Mechanical Addendum M-1

Date: August 30, 2023

Project: **Centre For Addiction and Mental Health
Move Consolidation – Interior Renovations**
250 College Street,
Toronto, Ontario,
M5T 1R8

Subject: Mechanical changes and/or additions

M-100

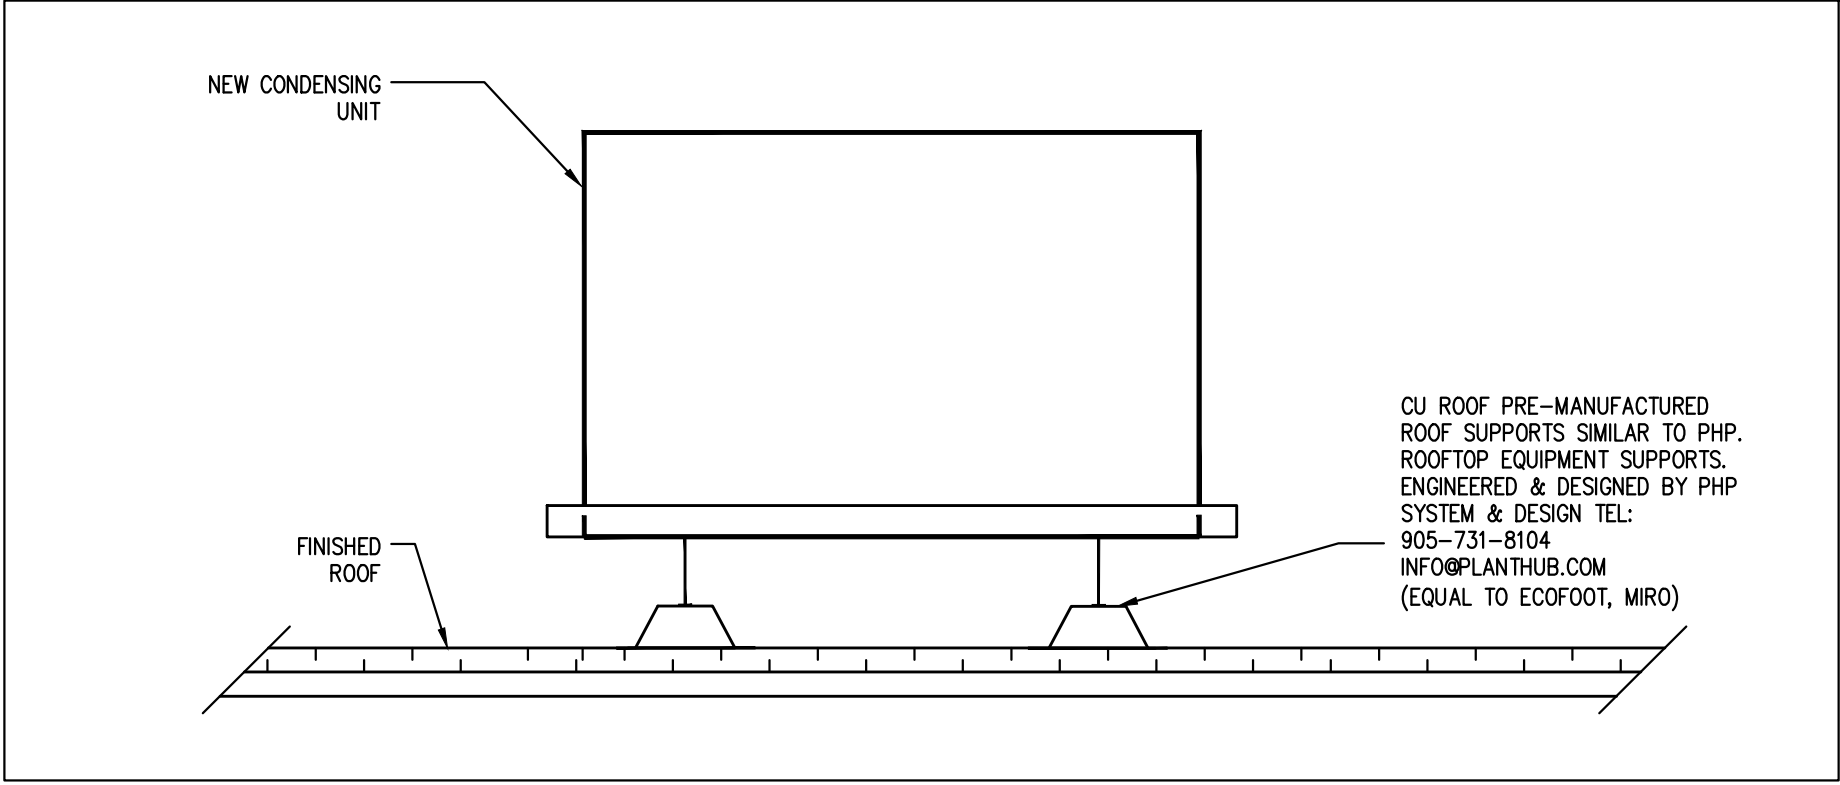
1. **Drawing M-100, Mechanical Legend, and Drawing List (Issued)**
 1. Mechanical drawing has been updated to reflect the revised drawing list.
2. **Drawing M-103, Mechanical Details and Equipment Schedules (Issued)**

MECHANICAL DETAILS & EQUIPMENT
SCHEDULE

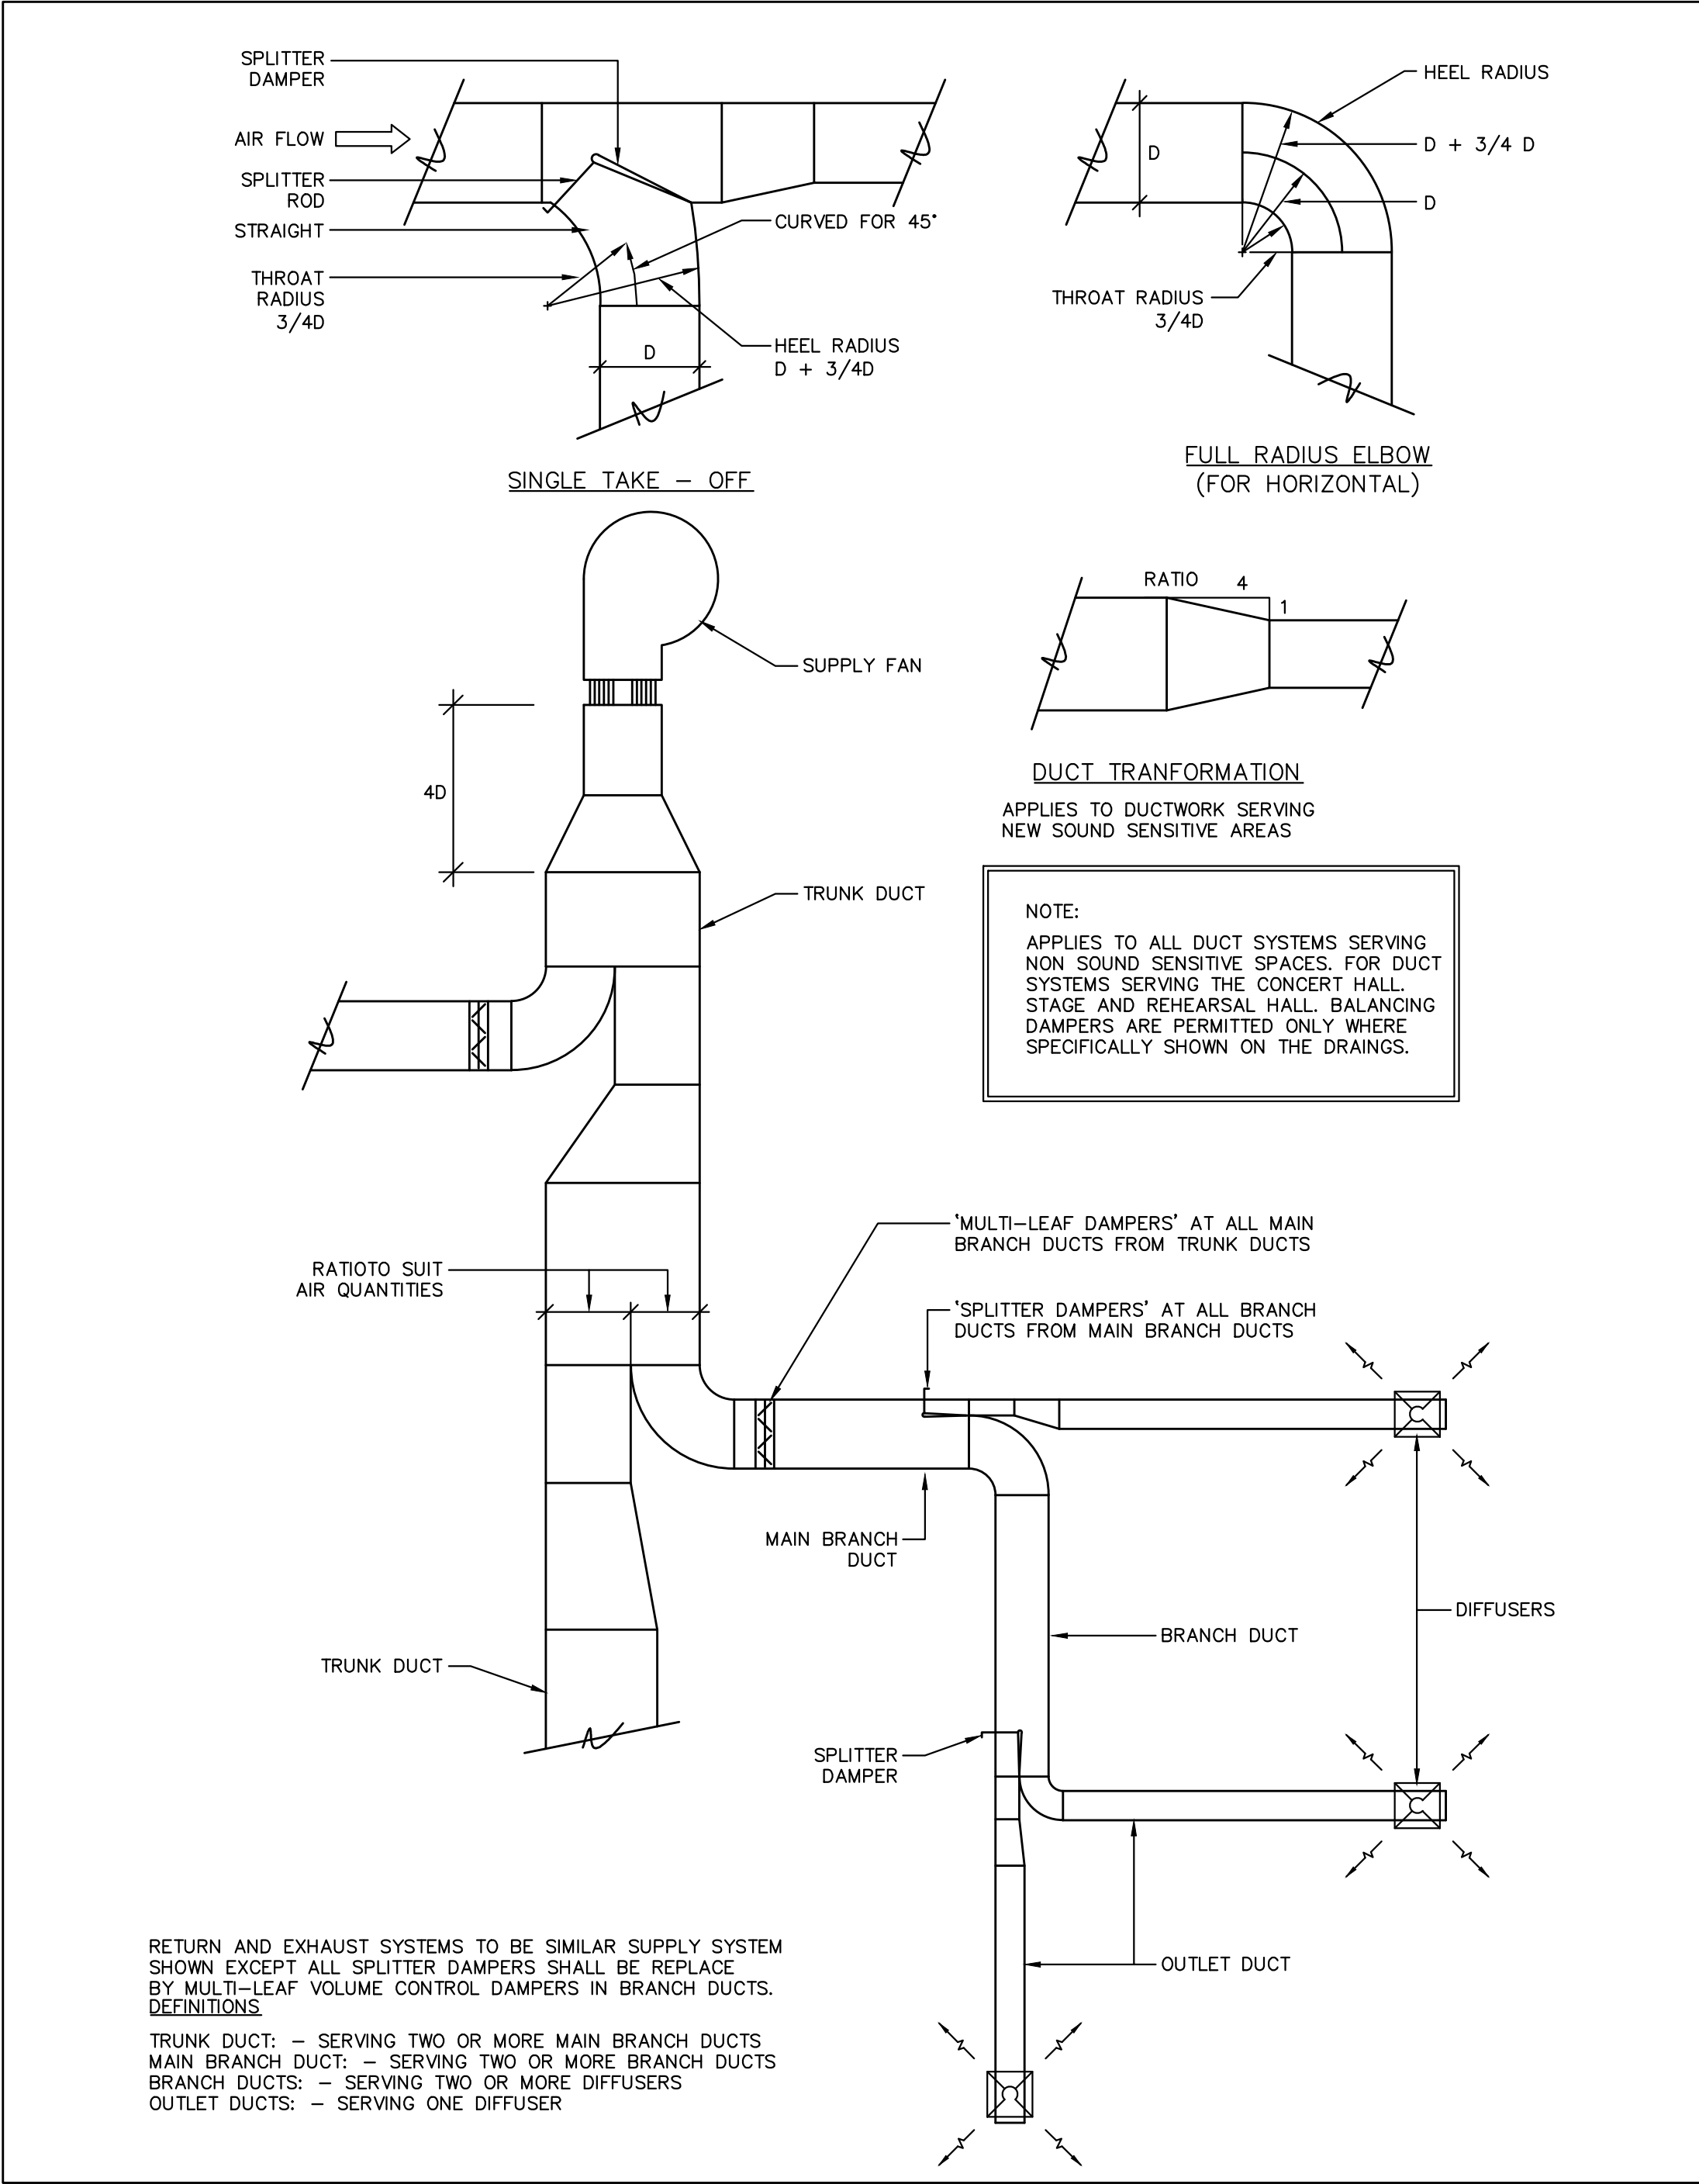
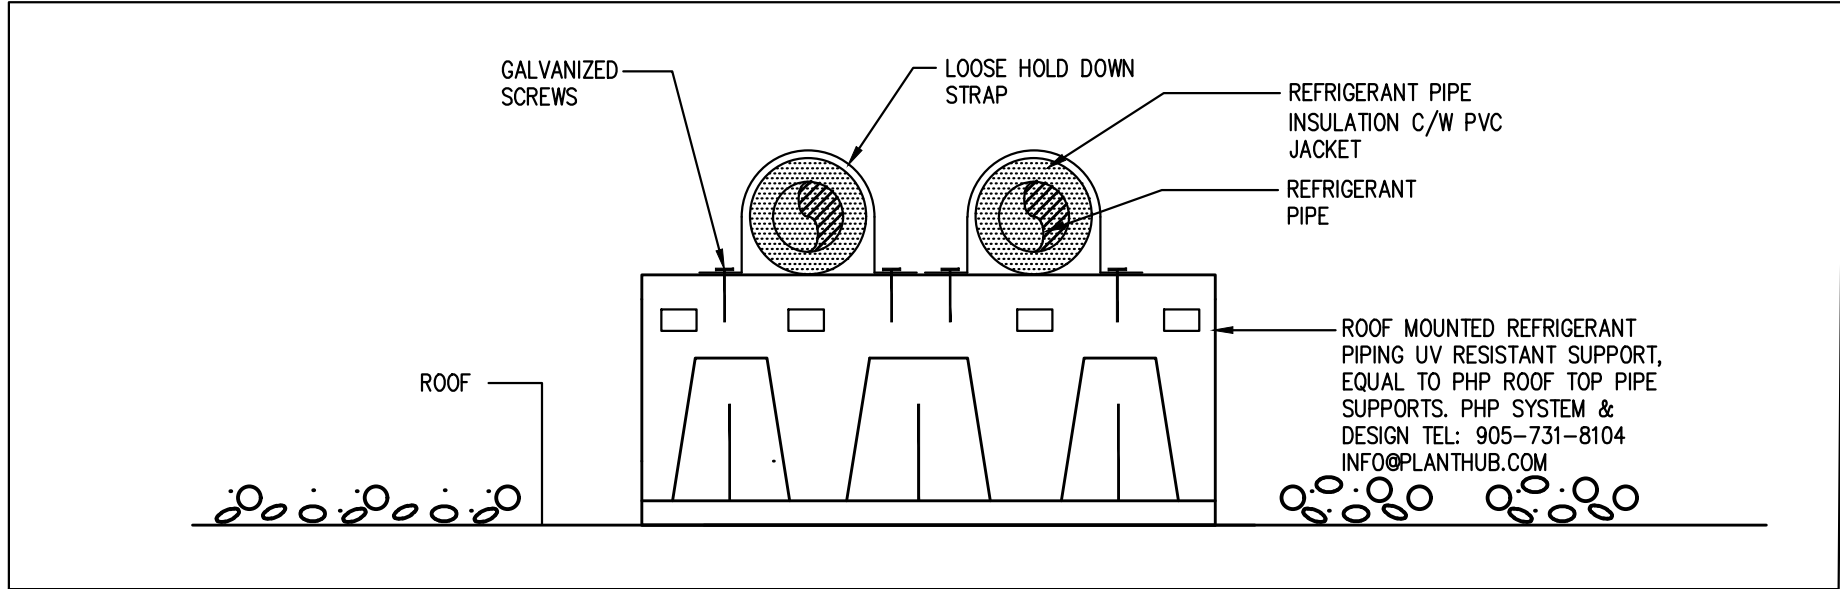
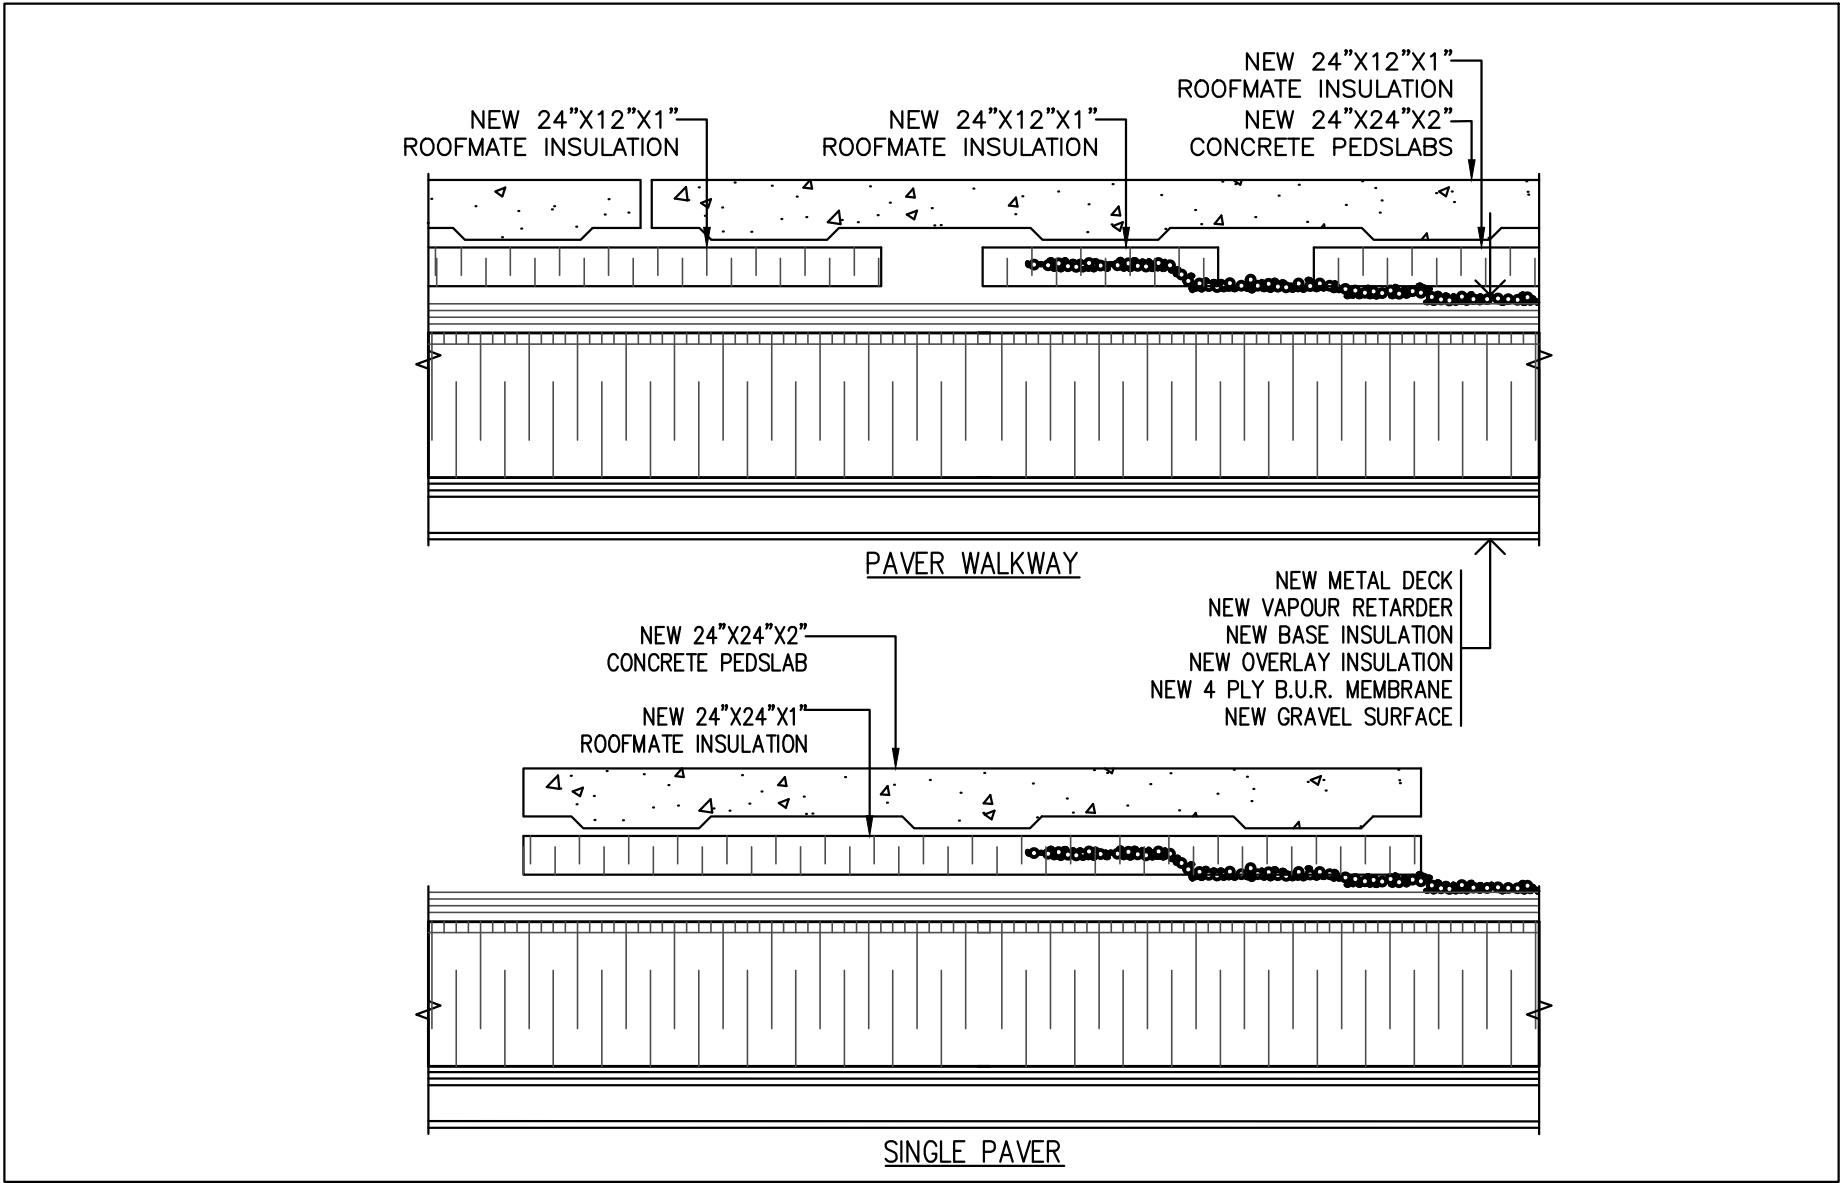
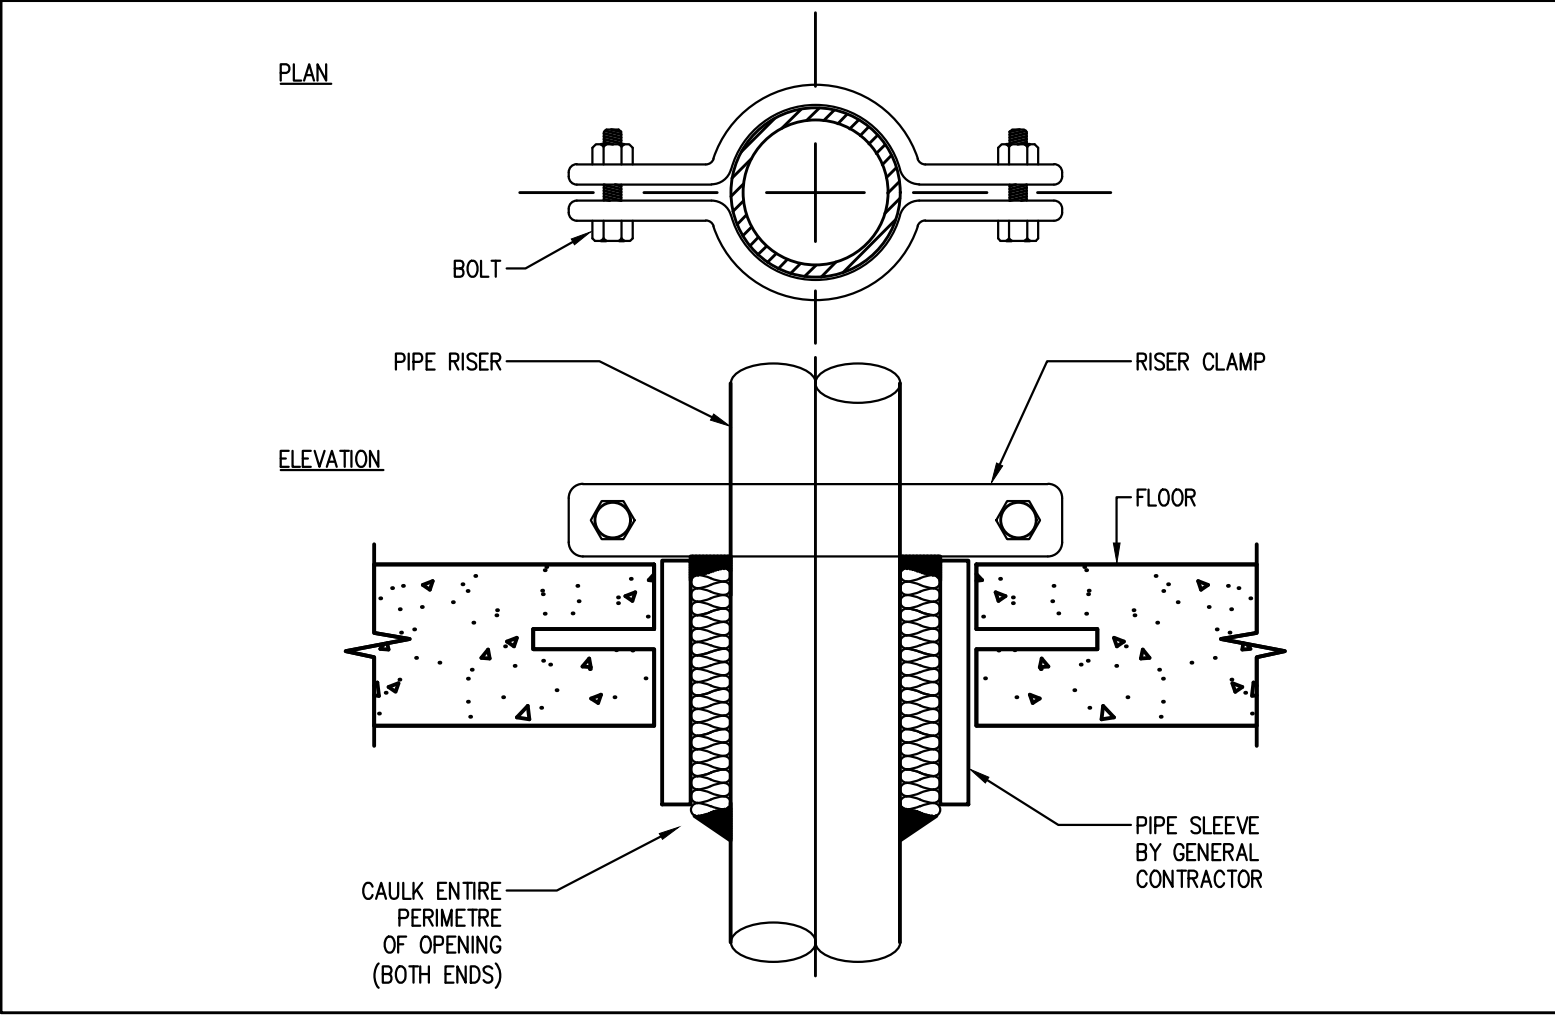
1. Mechanical drawing has been updated to reflect the EF-3 Service Area, and updated note for Detail 5/M-103.
3. **Drawing M-105, Mechanical Details and Equipment Schedule (Issued)**
